**SUBMITTAL TO THE BOARD OF SUPERVISORS
COUNTY OF RIVERSIDE, STATE OF CALIFORNIA**

SUBJECT: Construction of Briggs Road and Baxter Road and associated improvements in an unincorporated area north east of the City of Murrieta.

**ROAD IMPROVEMENTS ON
BRIGGS ROAD AND BAXTER ROAD
NORTH OF THE CITY OF MURRIETA
PROJECT No. C2-0156, MS 4089, IP 060030**

Addendum No. 1
Road Improvements on Briggs Road and Baxter Road
Project No. C2-0156, MS 4089, IP 060030
April 25, 2012
Page 5 of 7

SHEET NO: 3

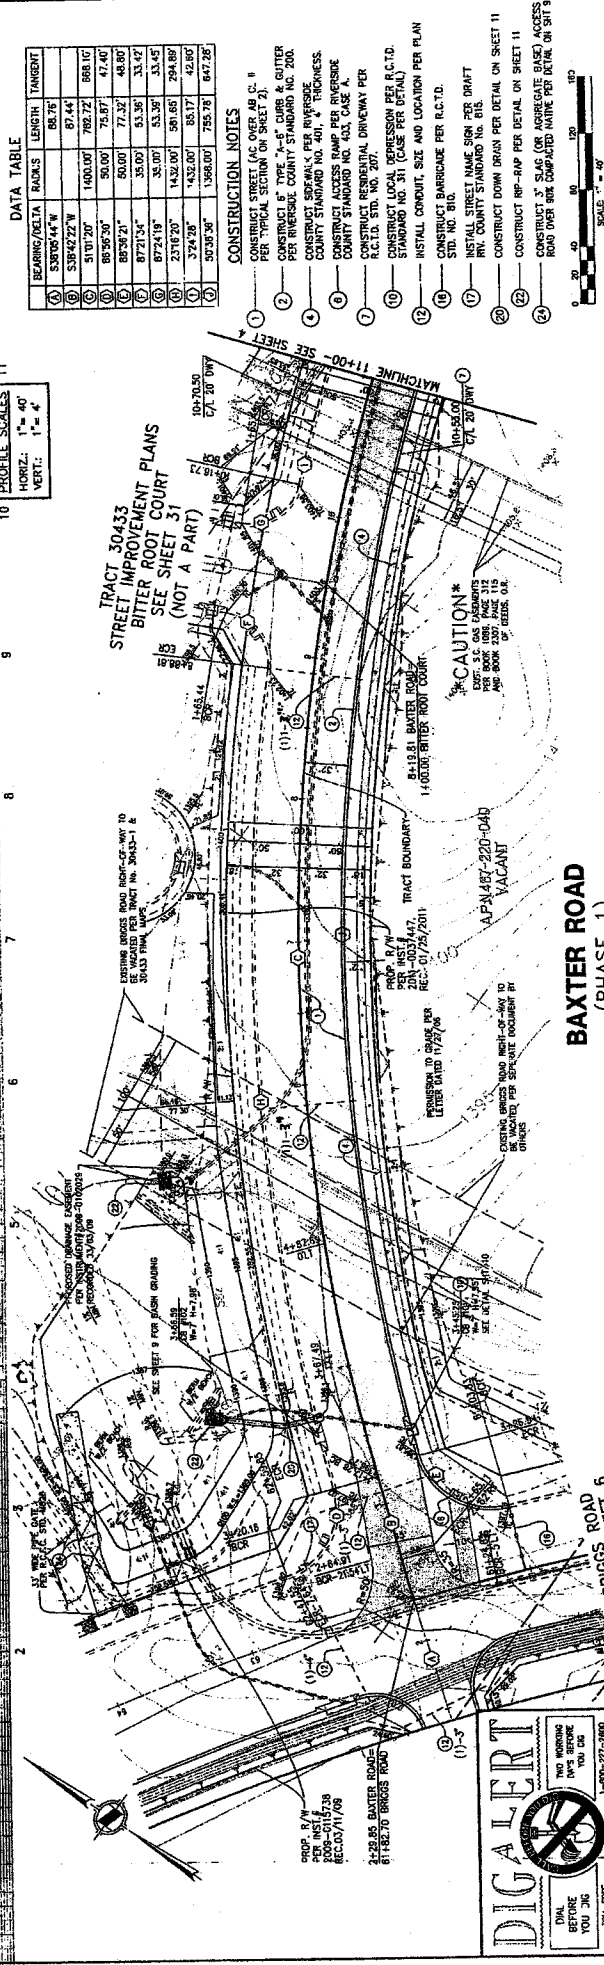
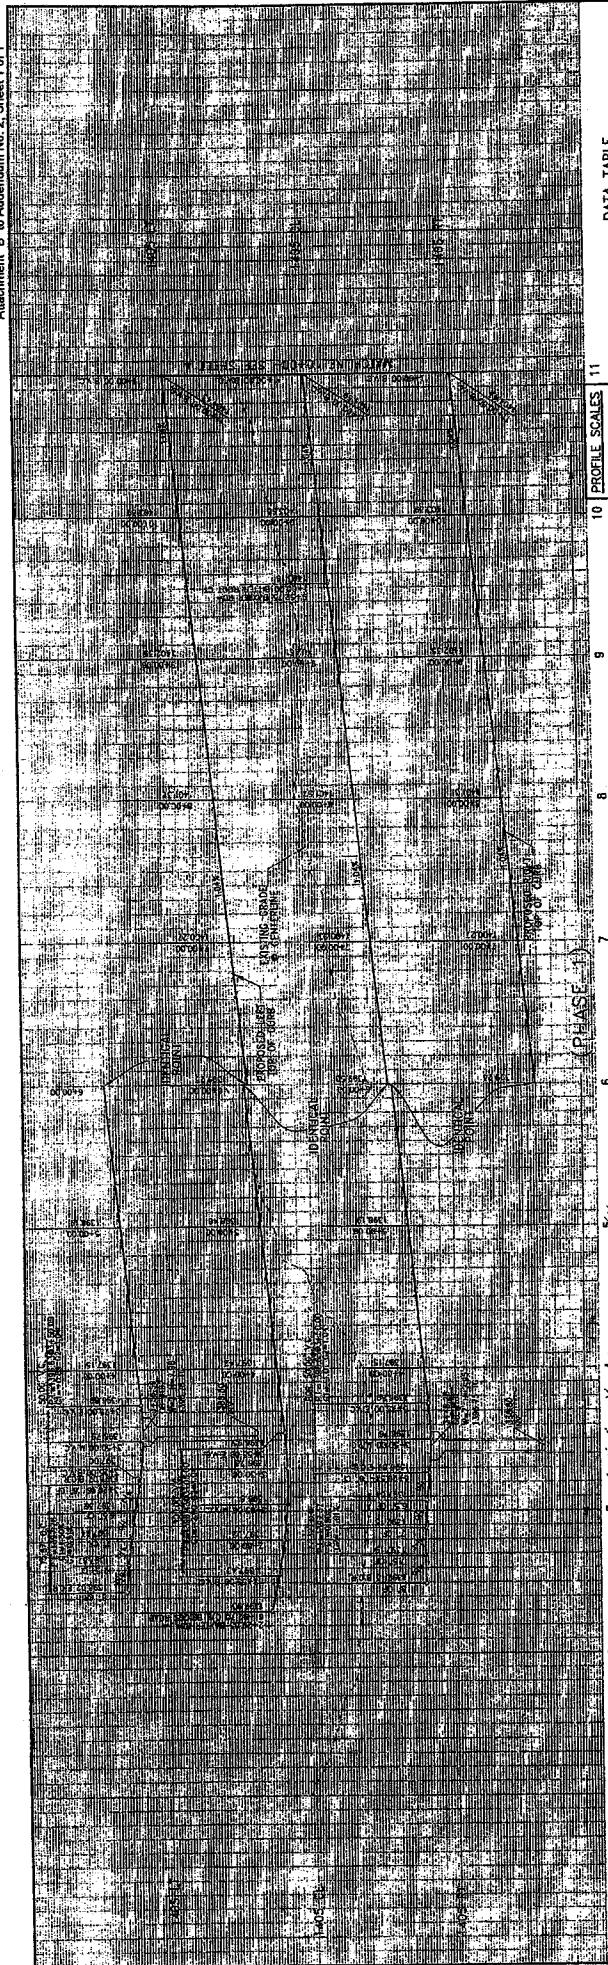
Item 9: Street Improvement Plans (Sheet 3 of 13)

Refer to Street Improvement Plans (Sheet 3 of 13), Delete Sheet 3 of 13 and replace with revised Sheet 3 of 13 issued with this addendum as **Attachment B** and made part hereof. This revised sheet is reprinted to clarify topography contour lines.
